Re: Barangaroo South, Building R1 – S96 Modification

This letter summarises our review of the S96 in relation to the proposed modification of the wording in relation to the provision of acoustic absorption above the occupied external areas of the building.

Figures 1-4 Reflected Ceiling Plans Showing Extent of Slotted Timbers Above Occupied Areas and West Elevation**Figure 1 – Ground Floor****Figure 2 – Level 1****Figure 3 – Level 2****Figure 4 – West elevation**

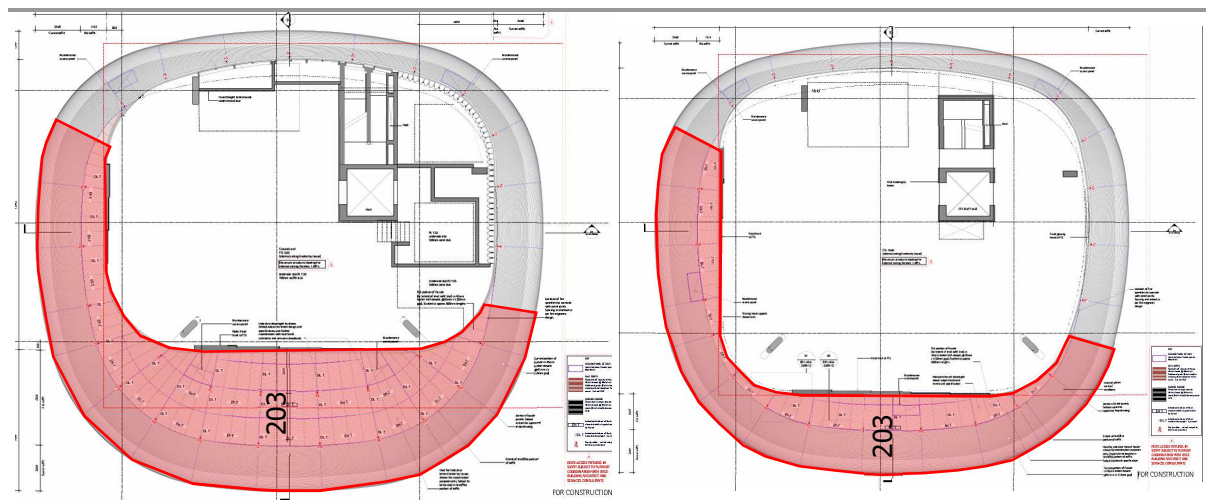
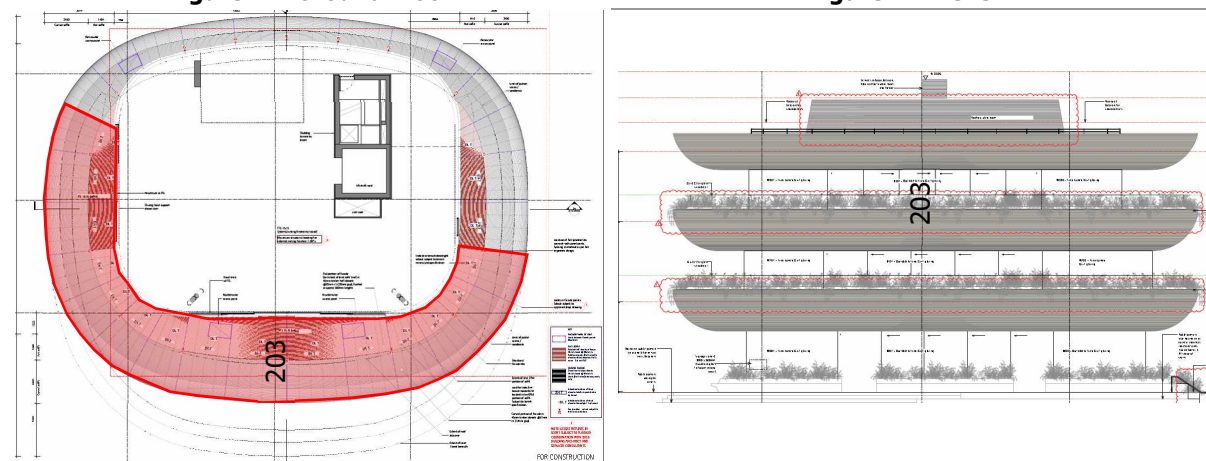
There are three levels of the building where patrons will be located outside and under the slotted timber areas mentioned in the conditions. Figures 1-4 show the RCP for the 3 floors and a west elevation. The areas highlighted in red represents the extend of slotted timbers above areas occupied by patrons. The most critical area on each level is the northern elevation (north of grid line 203) as this is closest to the residential building R9.

The external balconies have a curved slotted timber fascia, so the use of the word "underside" requires clarification. However, given noise is a critical issue at this location then we consider the absorptive treatment should be optimised across the whole premises. There are areas where an absorptive material with higher performance than NRC 0.85 can be used to offset "perceived" elimination of absorptive treatment in some areas.

The underside of the external balconies shall incorporate acoustic absorption above the horizontal plane of slotted timbers, excluding those areas above which are translucent panels. The extension of the acoustic absorption into the outer curved section of the slotted timbers (with respect to the cross-section elevation) shall be subject to the practicalities of installing such absorption having regard to the egress of rain. Such absorption shall be suitable for the outdoor space and have an NRC (Noise Reduction Coefficient) not less than 0.85 incorporated into the design.

Since the conditions and Noise Masterplan have strict noise limits to be achieved, then it is ultimately a combination of use of absorption and management of the premises which will achieve this criteria. For this reason, the condition can be reworded to allow a more flexible provision of absorption in some areas, with negligible change in acoustic outcomes.
